SUBJECT: ISSUANCE OF AMENDMENT NO. 3 TO FACILITY OPERATING LICENSE
NO. NPF-4 - NORTH ANNA POWER STATION, UNIT NO. 1

NORTH ANNA POWER STATION, UNIT NO. 1

License No. NPF-4
Amendment No. 3

Figure 3.2-1 Axial Flux Difference Limits as a Function of Rated Thermal Power

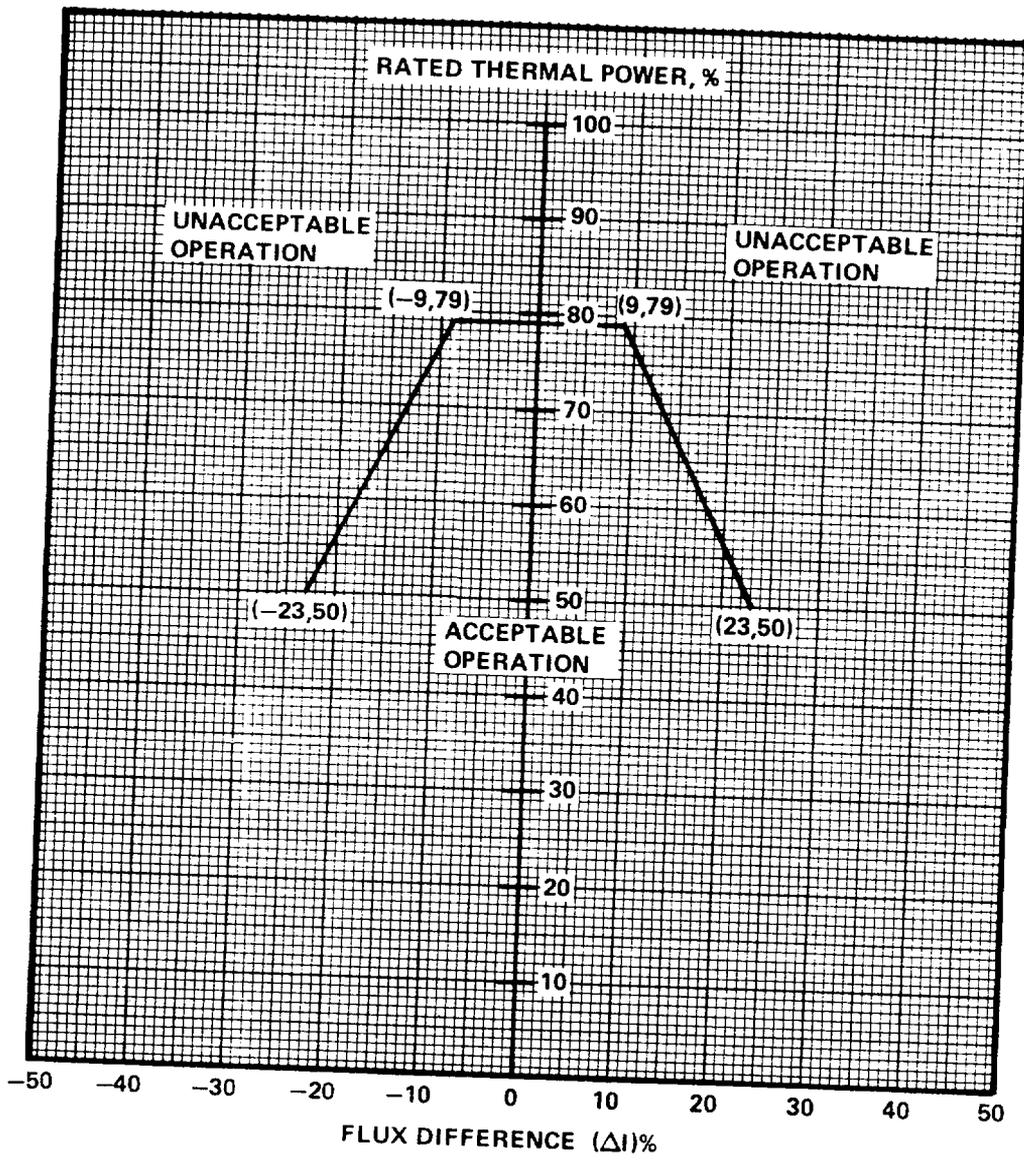
- 2) The indicated AFD is within the limits shown on Figure 3.2-1. Otherwise, reduce THERMAL POWER to less than 50% of RATED THERMAL POWER within 30 minutes and reduce the Power Range Neutron Flux-High Trip Setpoints to < 55% of RATED THERMAL POWER within the next 4 hours.

- b) Surveillance testing of the Power Range Neutron Flux Channels may be performed pursuant to Specification 4.3.1.1.1 provided the indicated AFD is maintained within the limits of Figure 3.2-1. A total of 16 hours of operation may be accumulated with the AFD outside of the target band during this testing without penalty deviation.

Figure 3.2-2 $K(Z)$ - Normalized $F_Q(Z)$ as a Function of Core Height

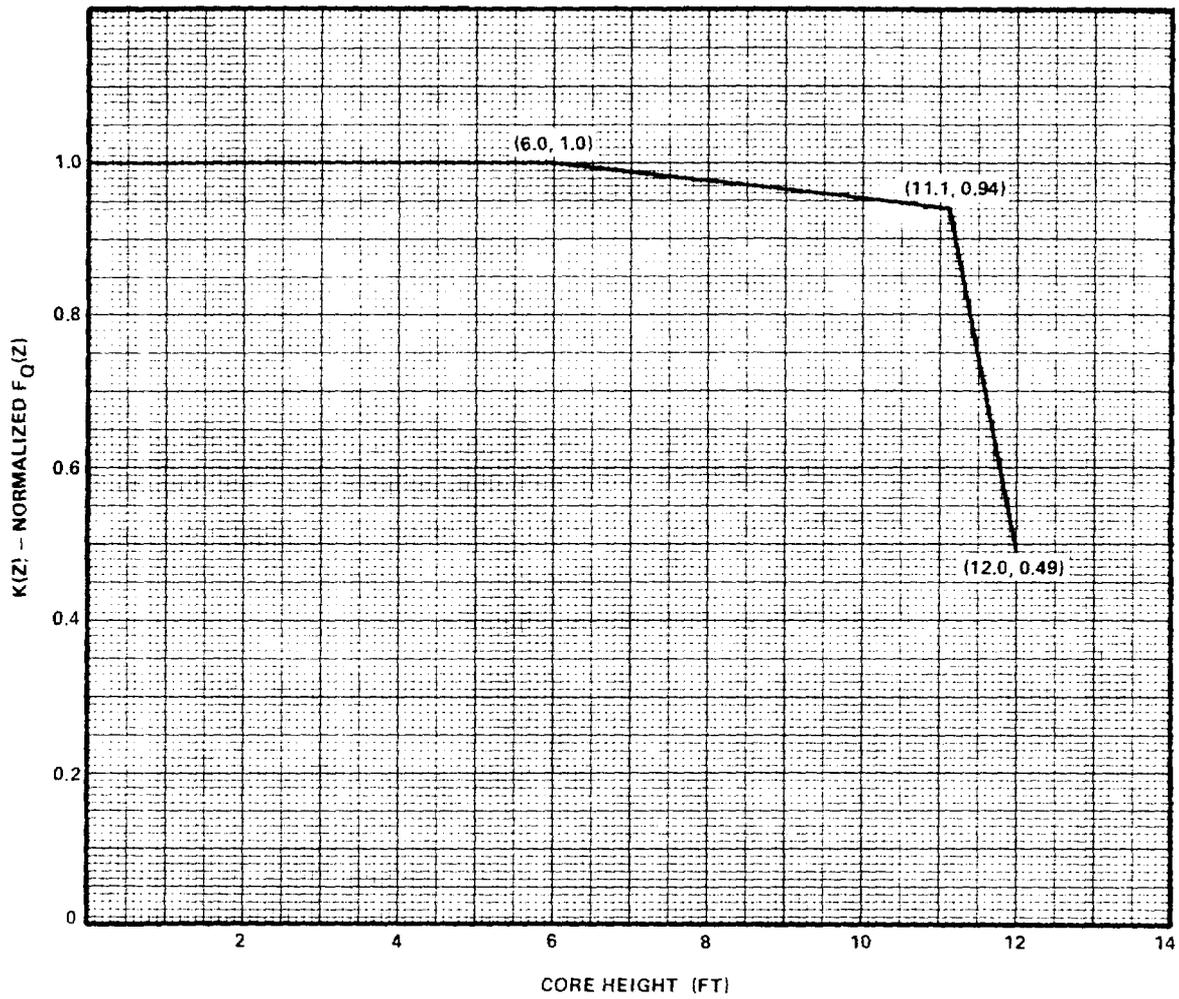
and $K(Z)$ is the function obtained from Figure 3.2-2 for a given core height location.

- $F_j(Z)$ is the normalized axial power distribution from thimble j at core elevation Z .
- P_L is the fraction of RATED THERMAL POWER.
- $K(Z)$ is the function obtained from Figure 3.2-2 for a given core height location.
- \bar{R}_j , for thimble j , is determined from at least $n=6$ in-core flux maps covering the full configuration of permissible rod patterns above 88% of RATED THERMAL POWER in accordance with:
